ADDENDUM NO. 1

HC Wheatley Institute 3<sup>rd</sup> Floor

## **Project: Wheatley Institute – 3<sup>rd</sup> Floor Renovation**

### **ADDENDUM NO. 1**

**M9243  
A4.3**

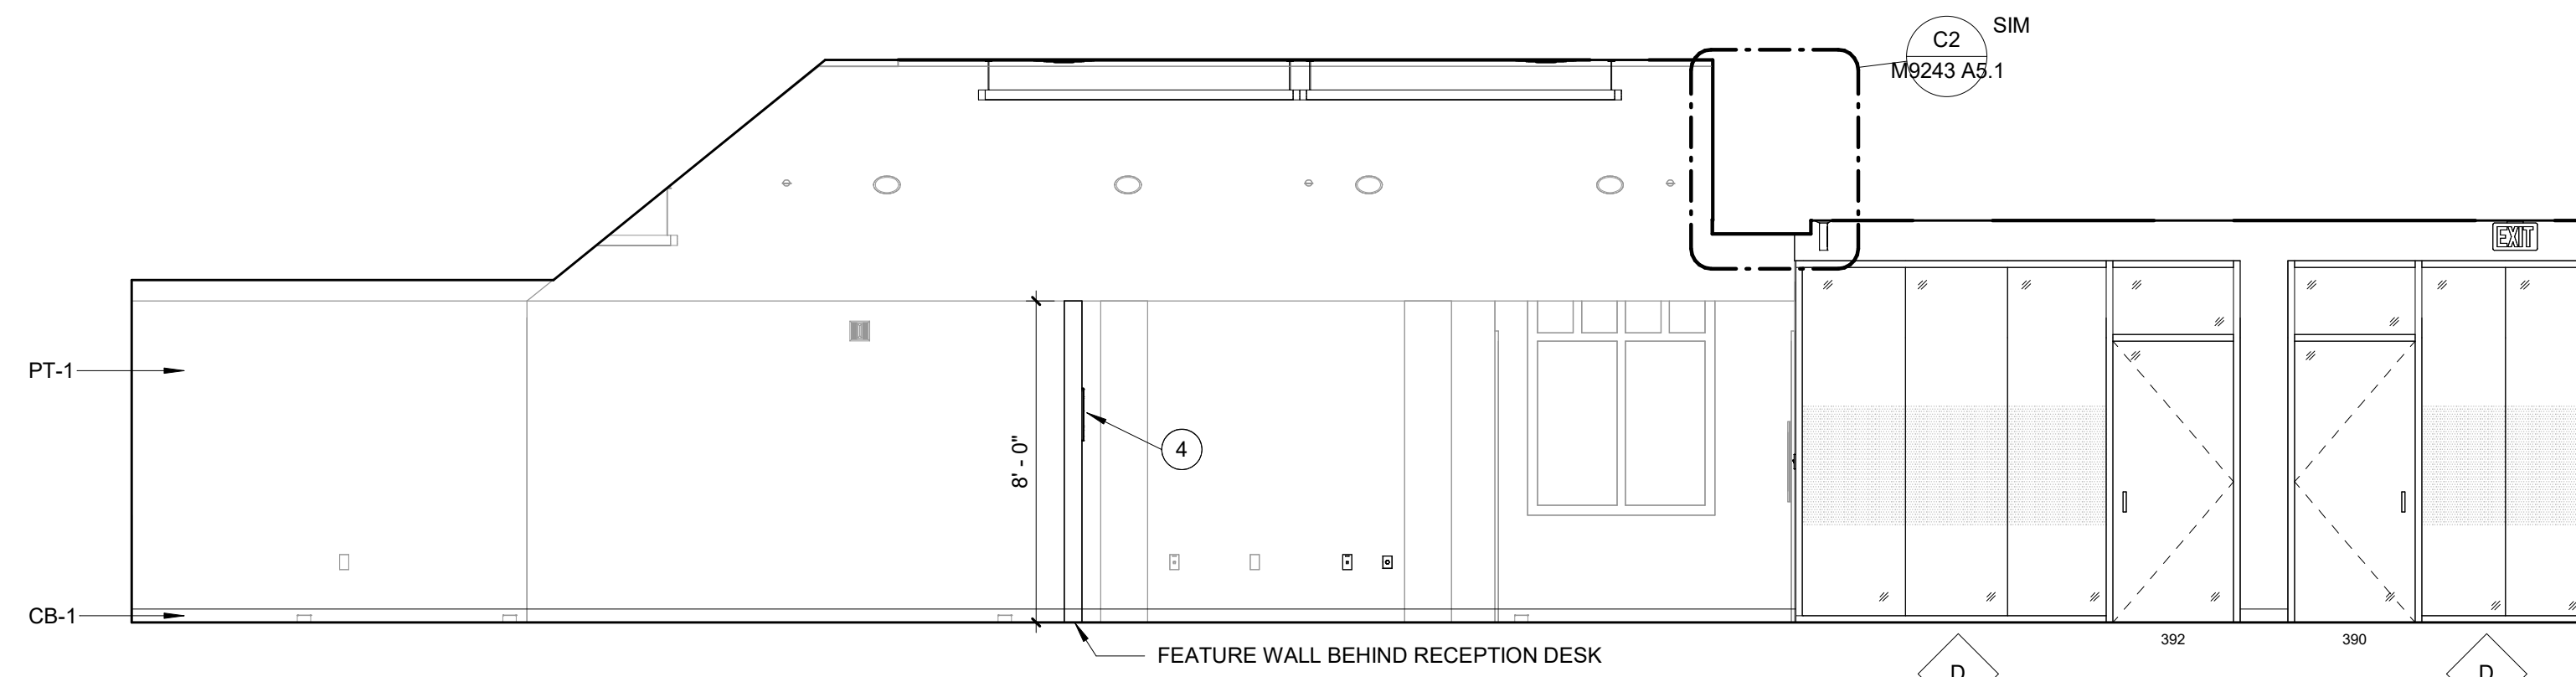
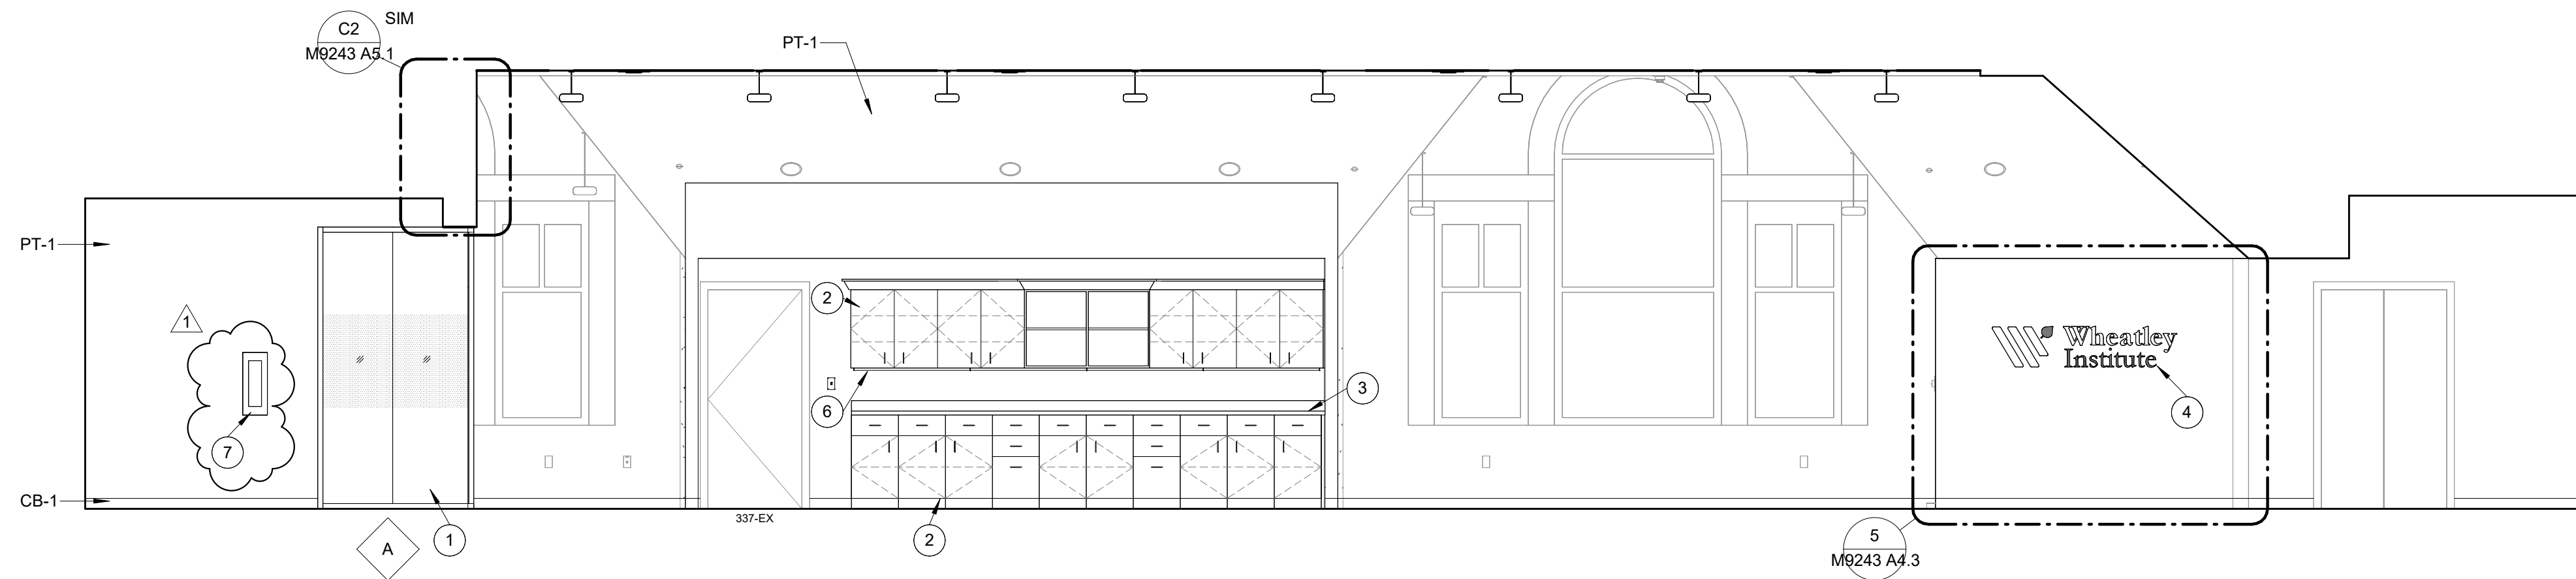
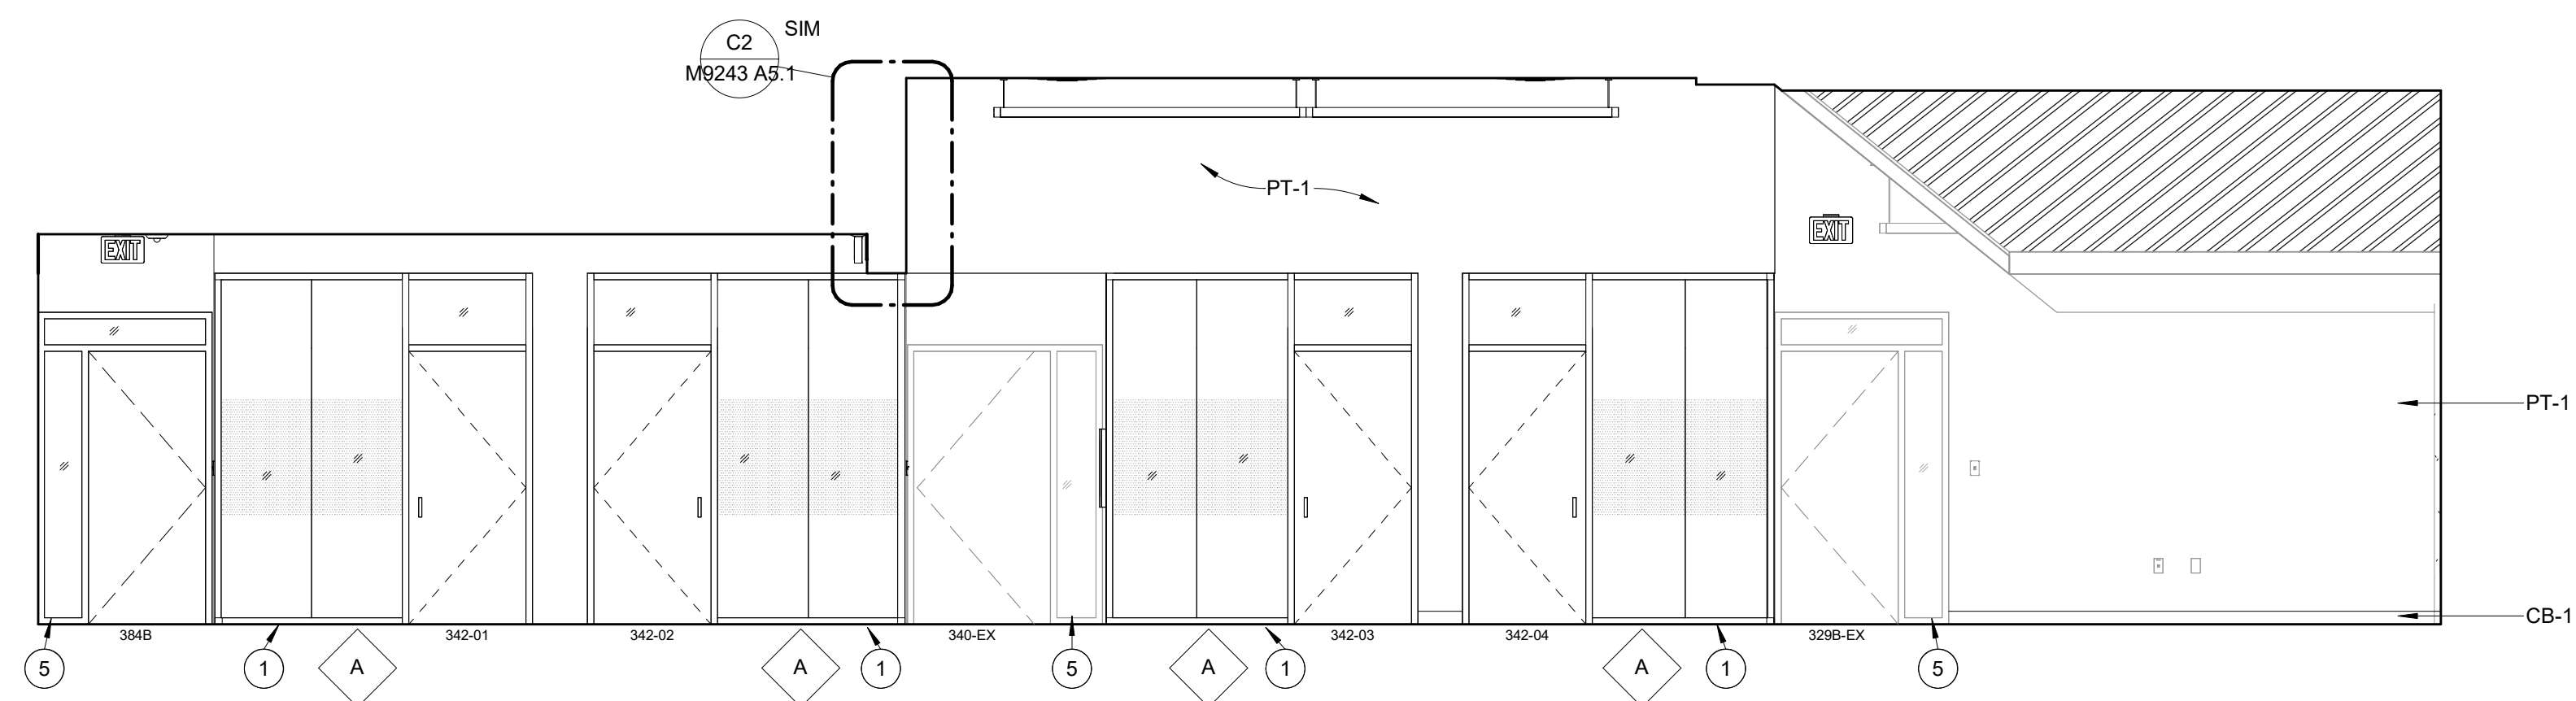
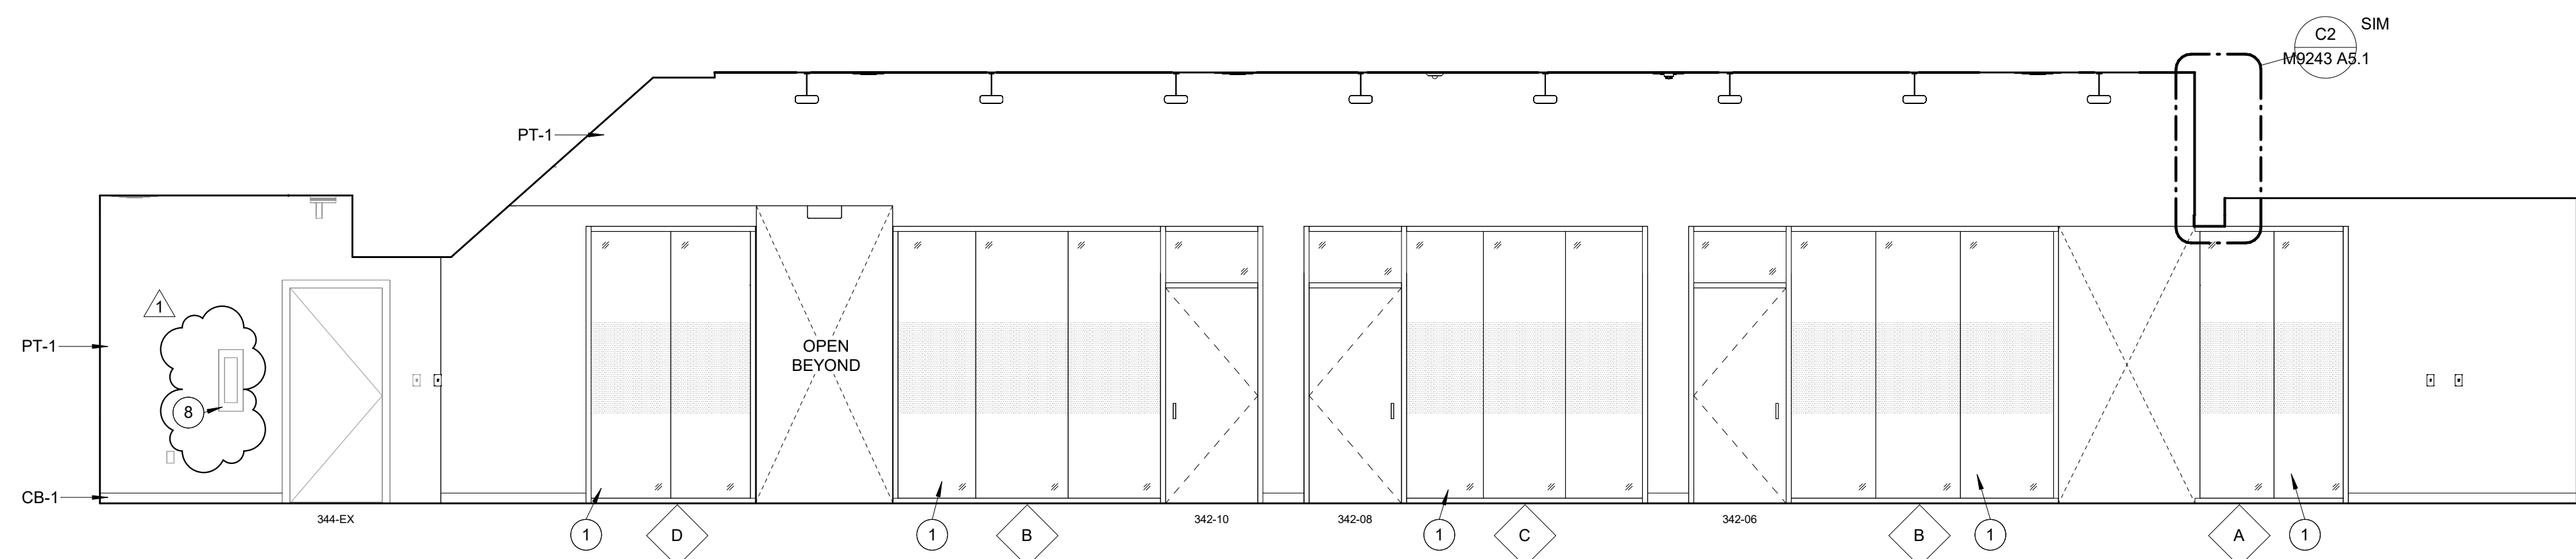
5. **Sheet A4.3:**
  - ADD: Detail Section Callout to drawing detail 5.
  - ADD: Sheet keynotes 7 & 8 to describe new and existing Fire Extinguisher Cabinets.

- REVISE: Detail 1 & 3 to show locations of Fire Extinguisher Cabinets and added sheet keynote references.
6. **Sheet A5.1:**
  - ADD: Detail D2 to sheet to show top of feature wall condition along with associated reference sheet keynote 17 to clarify scope on who responsibility to install wood cap.
